**GOLDEN GATE SWITCHBOARD CO.**  
1125 GOLDEN GATE DRIVE  
P.O. BOX 389  
NAPA, CALIFORNIA 94558

Pursuant to the requirement of Title 10, Chapter 1, Code of Federal Regulations-Energy-Part 21, we wish to report the following:

The failures occurred during endurance tests of a General Electric Co. AM4.16-350-1200 air circuit breaker, serial no. 269A8794-223. Similar breakers are in use in nuclear power plants throughout the United States of America. These tests are being conducted in connection with a contract to supply switchgear for the Maanshan Nuclear Power Station in Taiwan, Republic of China.

Figure 4. (8040405) Right Side View ML-13 Operating Mechanism

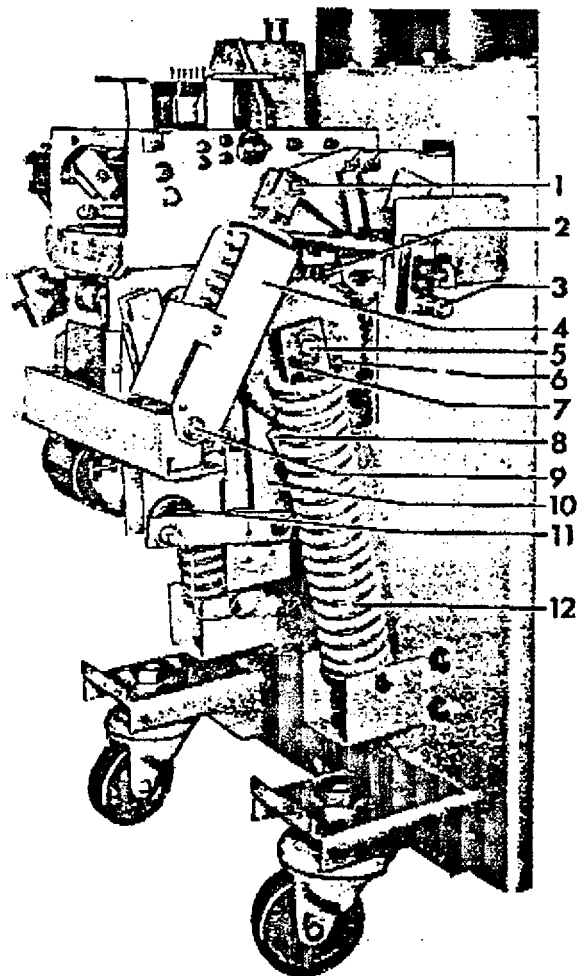
After 1,927 closures (at the rate of approximately 90 per hour), the shaft that mounts the ratchet driving pawl, (Part 8, Figure 4, ref. (1)), broke at the weld allowing the charging mechanism to run continuously without charging the springs.

The driving pawl lever, (Part 10, Fig. 4), was replaced and tests were continued.

After a total of 2,282 closures, one of the cotter pins which secure the latching pawl shaft, (Part 2, Fig. 4), broke and the shaft dropped out allowing the charging mechanism to run continuously without charging the springs. The cotter pins were replaced and the test was resumed. After approximately 560 additional operations, one of the replacement cotter pins failed.
